Access Compliance Report

Public Rights-of-Way (Curb Ramps)

Intersection ID: 30124	Main Street: CLOONEY_LN	Cross Street: OLDE_JUSTIN_PL	Location: SE
ADA ID: 4E27C8297595	Ramp Type: BlendTrans1	Initial Pass/Fail: Fail	Overall Compliance: No
		Severity Score: 8.75

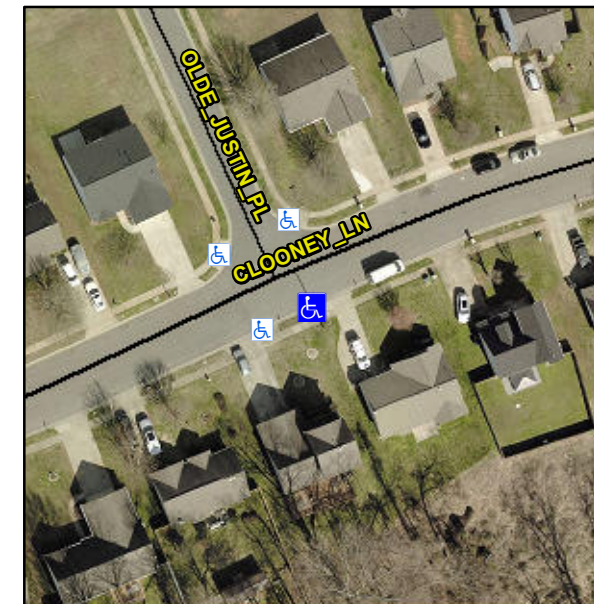
R304.5.1

Compliance	Description	Data	Compliance	Description	Data
N/A	Ramp Length (in)	44.0	Yes	BlendTrans Slope (%)	4.6
No	Ramp Width (in)	40.0	Yes	BlendTrans XSlope (%)	0.9
N/A	Flare Type LT	N/A	N/A	Flare Type RT	N/A
N/A	Flare Slope LT (%)	N/A	N/A	Flare Slope RT (%)	N/A
N/A	Flare Traversable LT?	N/A	N/A	Flare Traversable RT?	N/A
N/A	Landing Length (in)	N/A	N/A	DWS Provided?	N/A
N/A	Landing Width (in)	N/A	N/A	DWS Contrast?	N/A
N/A	Landing Slope (%)	N/A	N/A	DWS Length (in)	N/A
N/A	Landing X Slope (%)	N/A	N/A	DWS Full Width?	N/A
N/A	Landing Curb? (Y/N)	N/A	N/A	DWS Offset (in)	N/A
N/A	Shared Landing?	N/A			
N/A	Gutter Ponding?	N/A	N/A	Gutter Slope (%)	N/A
N/A	Gutter Lip Ht (in)	N/A	N/A	Gutter X Slope (%)	N/A
N/A	Painted X Walk1?	No	N/A	Painted X Walk2?	N/A
	X Walk 1 Direction	To N		X Walk 2 Direction	N/A
	X Walk 1 Width (in)	N/A		X Walk 2 Width (in)	N/A
	X Walk 1 Slope (%)	2.1		X Walk 2 Slope (%)	N/A
	X Walk 1 X Slope (%)	0.3		X Walk 2 X Slope (%)	N/A

Remove & Replace Curb Ramp With Two New Directional Ramps or Equivalent.
